Technical Service Bulletin

94E4 UPDATE - Repairing Headlights (NVLW)

94 12 65 2022790/3 February 14, 2012. Supersedes Technical Service Bulletin Group 94 number 11 – 50 dated July 12, 2011 for reasons listed below.

Model(s)	Year	VIN Range	Vehicle-Specific Equipment
А3	2009	098502 – 103702	Not Applicable

Figure 1. Area to be modified, veiwed with hood open.

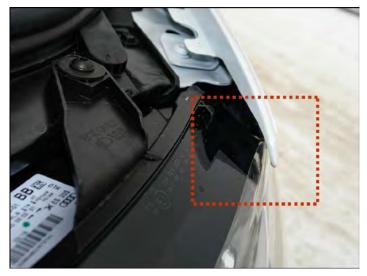
A clip on the headlight contacts the fender.

Remove clip on both headlights and apply cavity-sealing wax.

Open hood.

2. Apply screwdriver and remove clip with a gentle tap (left and right headlight).

3. Spray any abrasion with cavity sealing wax.
